**CITY OF UNLEY**

**COUNCIL ASSESSMENT PANEL**

**20 October 2020**

**ITEM 1****DEVELOPMENT APPLICATION – 090/224/2020/C2 – 44 PARK STREET,  
HYDE PARK SA 5061 (UNLEY)**

**Diagram 1: Illustration of existing and proposed dwelling setbacks and angle of view of the LHP for eastbound pedestrians and motorists**

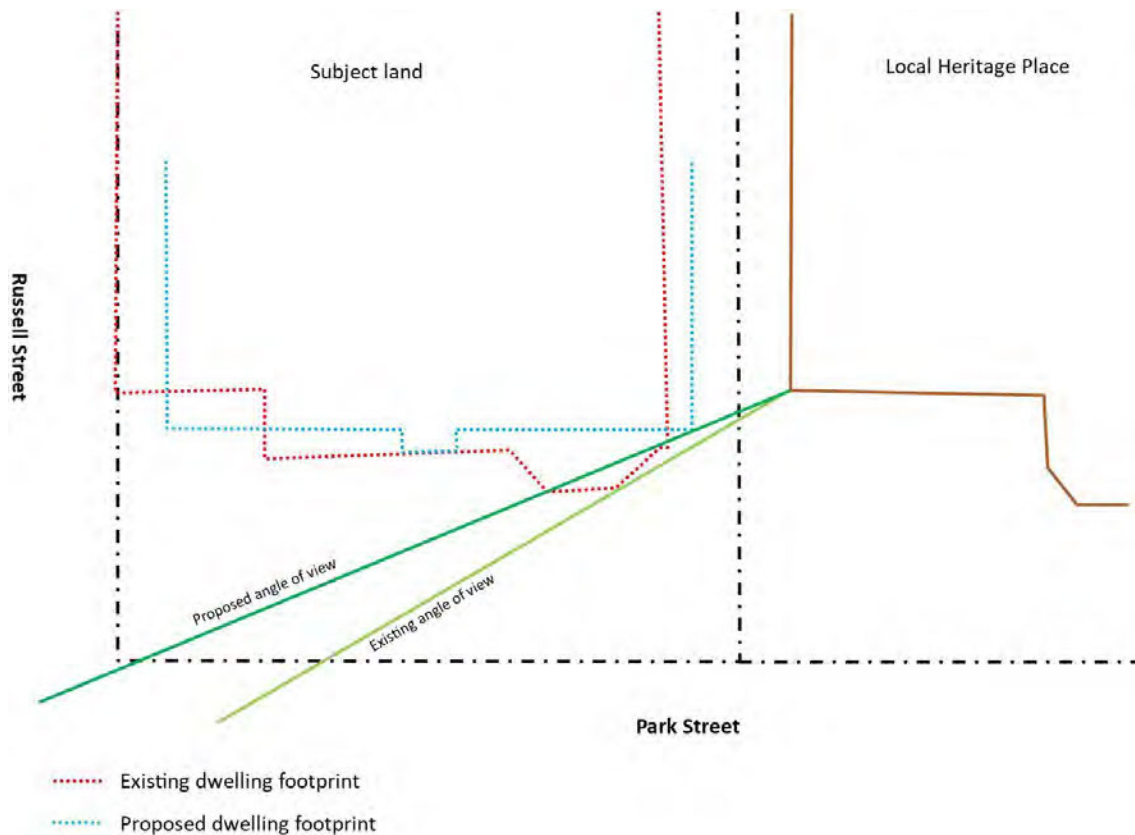
We consider this front setback of the proposal to not materially detract from the adjoining Local Heritage Place (LHP) because:

- The existing dwelling on the subject land has a bay window currently sitting forward of the main face of the associated dwelling and the adjoining (LHP) dwelling i.e. it is setback 4813mm and the associated dwelling and adjoining dwellings are setback 7.5m and 6m respectively.
- By our assessment this bay window currently limits the view of the adjoining Local Heritage Place (LHP) from pedestrians and motorists travelling east bound along Park Street due to its protuberance forward of the main face of the dwelling.
- The proposed dwelling setback at 6340mm will provide a wider angle of view of the LHP as viewed travelling eastbound along Park Street.
- The below diagram provides an illustration of the existing and proposed angle of view to the LHP. The diagram clearly demonstrates the extended angle of view the proposed dwelling will provide to the LHP.

The applicant seeks to retain the proposed front setback of 6340mm and upon our further review we contend that the proposal will satisfy provisions of the Development Plan with regards to setback whilst increasing the angle of view of the adjoining LHP for eastbound pedestrians and motorists (thereby improving the situation from the current scenario).

### Roof Plan

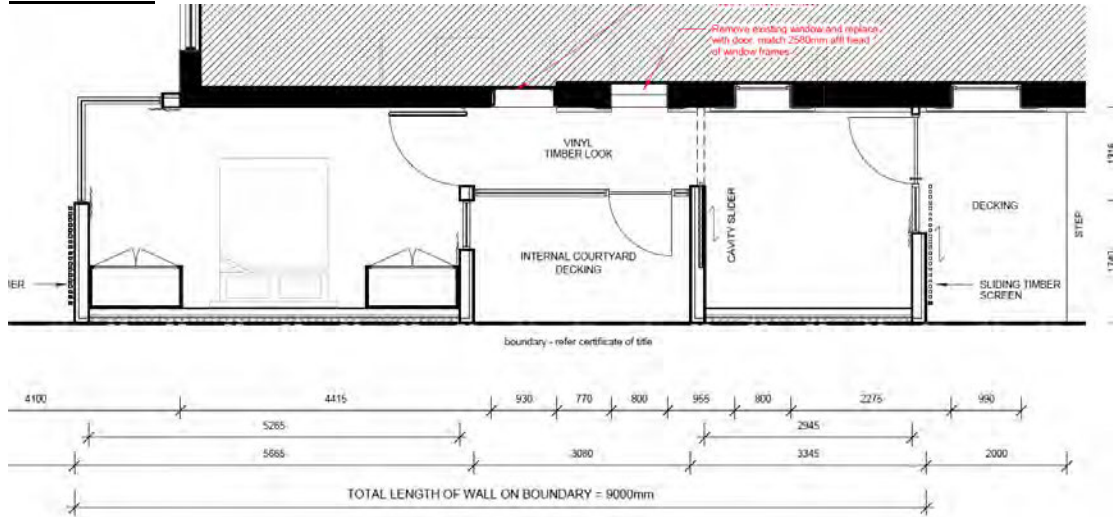
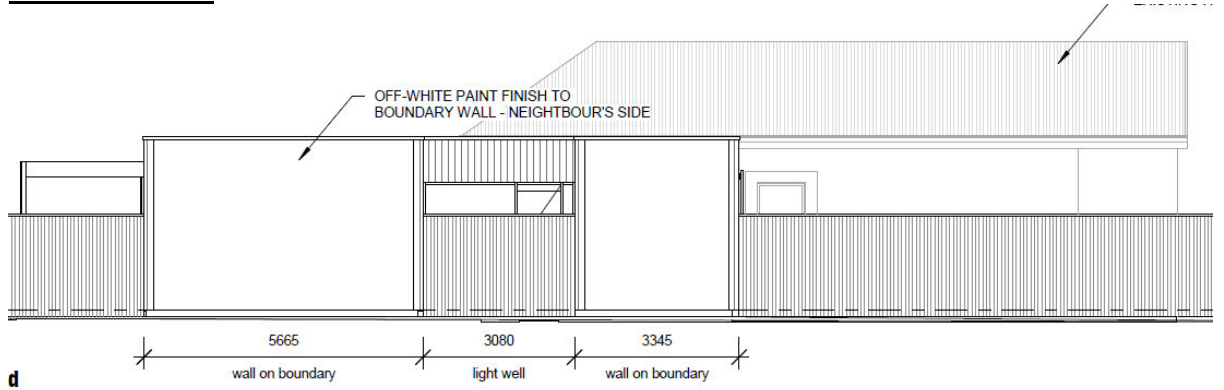
Stormwater catchment – how will the increased stormwater be disposed of?	The stormwater will connect to the existing drainage and be discharged from the site as per regulations.
Impact to residents wellbeing as elderly resident utilises kitchen/ family room all day, every day	Not wanting to diminish the importance of resident wellbeing, the original proposal has been amended to accommodate and address the concerns expressed by the representor.
Not in character with the environment and will intrude on neighbour's spacious conditions	The proposed addition is contemporary in nature in order to not try and mimic the existing. A common and accepted practice when proposing contemporary additions of character houses is to design them in a way to visually recede as much as practical from the streetscape.
Car parking – limited space to house 2 vehicles in the driveway	Car parking concerns have been addressed by the amended proposal.

- 2 - Wall on boundary is proposed as 3500mm H x 9000mm L as per drawings. The 3500mm height on boundary is required to accommodate an internal detail which allows a ceiling height, that mitigates a clash with existing external window head heights. The resulting 3500mm height is then required to allow for roof structure and falls for stormwater management.

9 - Carparking concerns have been addressed by the adjustment and updated proposal. 2 Cars are comfortably accommodated with the revised design.
